# Access Compliance Report

### (Curb Ramps)

Intersection ID: 12356	Main Street: BOST_ST	Cross Street: CRISPIN_AV	Location: SE
ADA ID: D3B44D52353E	Ramp Type: Para	Initial Pass/Fail: Fail	Overall Compliance: No
Severity Score: 13.75			
Codes/Mitigation Info/Possible Solution		Field Measurements/Component Compliance

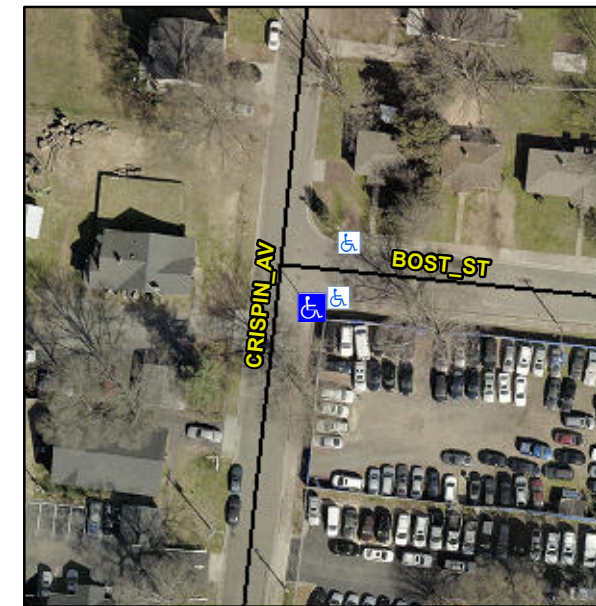
**R304.3.2, R304.5.3**

Compliance	Description	Data	Compliance	Description	Data
N/A	Ramp Length LT (in)	80.0	N/A	Ramp Length RT (in)	80.0
Yes	Ramp Width LT (in)	72.0	Yes	Ramp Width RT (in)	72.0
Yes	Ramp Slope LT (%)	5.2	No	Ramp Slope RT (%)	9.3
Yes	Ramp XSlope LT (%)	0.9	No	Ramp XSlope RT (%)	3.8
N/A	Landing Length (in)	N/A	N/A	DWS Provided?	N/A
N/A	Landing Width (in)	N/A	N/A	DWS Contrast?	N/A
N/A	Landing Slope (%)	N/A	N/A	DWS Length (in)	N/A
N/A	Landing X Slope (%)	N/A	N/A	DWS Full Width?	N/A
N/A	Landing Curb? (Y/N)	N/A	N/A	DWS Offset (in)	N/A
N/A	Shared Landing?	N/A			
N/A	Gutter Ponding?	N/A	N/A	Gutter Slope (%)	N/A
N/A	Gutter Lip Ht (in)	N/A	N/A	Gutter X Slope (%)	N/A
N/A	Painted X Walk1?	No	N/A	Painted X Walk2?	N/A
	X Walk 1 Direction	To N		X Walk 2 Direction	N/A
N/A	X Walk 1 Width (in)	N/A	N/A	X Walk 2 Width (in)	N/A
	X Walk 1 Slope (%)	0.3		X Walk 2 Slope (%)	N/A
	X Walk 1 X Slope (%)	0.2		X Walk 2 X Slope (%)	N/A
N/A	Ramp inside XWalk1?	N/A	N/A	Ramp inside XWalk2?	N/A

**Remove & Replace Entire Ramp.**
